ORDINANCE NO. 1396

AN ORDINANCE AMENDING CHAPTER 15 OF THE BENBROOK MUNICIPAL CODE (1985), AS AMENDED, BY ADOPTING THE 2015 EDITION OF THE INTERNATIONAL BUILDING CODE AND LOCAL AMENDMENTS; ADOPTING THE 2015 EDITION OF THE INTERNATIONAL RESIDENTIAL CODE AND LOCAL AMENDMENTS; ADOPTING THE 2015 EDITION OF THE INTERNATIONAL ENERGY CONSERVATION CODE AND LOCAL AMENDMENTS; ADOPTING THE 2015 EDITION OF THE INTERNATIONAL PLUMBING CODE AND LOCAL AMENDMENTS; ADOPTING THE 2015 EDITION OF THE INTERNATIONAL FUEL GAS CODE AND LOCAL AMENDMENTS; ADOPTING THE 2015 EDITION OF THE INTERNATIONAL FIRE CODE AND LOCAL AMENDMENTS; AND ADOPTING THE 2015 EDITION OF THE INTERNATIONAL MECHANICAL CODE AND LOCAL AMENDMENTS; PROVIDING FOR THE MODIFICATION OF THE CODES TO INCORPORATE LOCAL AMENDMENTS; PROVIDING FOR THE RECORDING OF THE BUILDING, RESIDENTIAL, ELECTRICAL, ENERGY CONSERVATION, PLUMBING, FUEL GAS, FIRE, AND MECHANICAL CODES AS A PUBLIC RECORD; PROVIDING THAT THIS ORDINANCE SHALL BE CUMULATIVE OF ALL ORDINANCES; PROVIDING A SEVERABILITY CLAUSE; PROVIDING FOR A PENALTY FOR VIOLATIONS; PROVIDING A SAVINGS CLAUSE; PROVIDING FOR PUBLICATION IN PAMPHLET FORM; PROVIDING FOR PUBLICATION IN THE OFFICIAL NEWSP

Figure R602.6.1; delete the figure and insert the following figure:

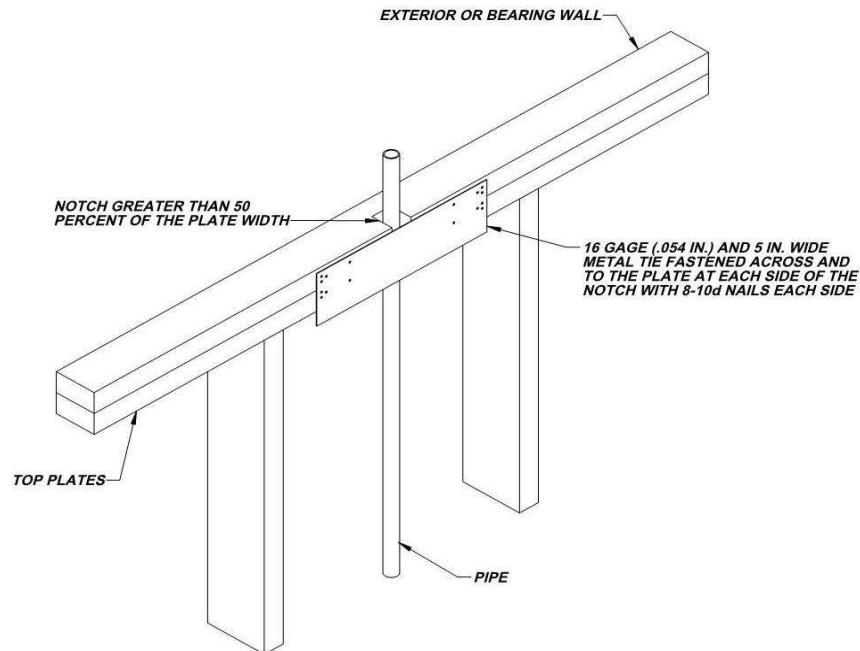
R602.6.1 Drilling and notching of top plate. When piping or ductwork is placed in or partly in an exterior wall or interior load-bearing wall, necessitating cutting, drilling or notching of the top plate by more than 50 percent of its width, a galvanized metal tie not less than 0.054 inch thick (1.37 mm) (16 Ga) and 5 inches (127 mm) wide shall be fastened across and to the plate at each side of the opening with not less than

eight 10d (0.148 inch diameter) having a minimum length of 1 ½ inches (38 mm) at each side or equivalent. Fasteners will be offset to prevent splitting of the top plate material. The metal tie must extend a minimum of 6 inches past the opening. See figure R602.6.1. {remainder unchanged}
